**MODEL: 8571 DigiTOL® PARTS COUNTING SCALE**

**SUBJECT: CLEARING E3 ERRORS, ADDITION TO BULLETIN I-19-90**

12/26/90 I-24-90

Figure 1 - 8571 Main PCB

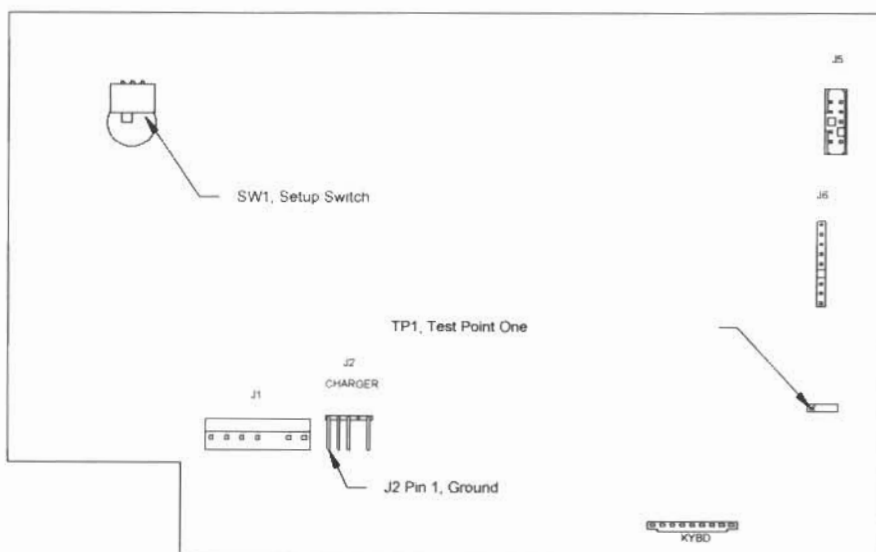
Service bulletin I-19-90, describes an E3 error code condition caused by removing power from the Model 8571 scale during calibration. The service bulletin incorrectly states that the 8571 Main PCB, part number \*129332 00A, must be replaced to clear an E3 error code. It is possible to clear an E3 error condition by performing the diagnostic test described on page 20 in Section 3 of the troubleshooting section of the 8571 technical manual, TM008571 I01.

The 8571 diagnostic procedure is accessed by powering up the 8571 with TP1 (test point 1) jumpered to logic ground (connector J2, pin 1). Refer to Figure 1 for J2, pin 1 and TP1 location.
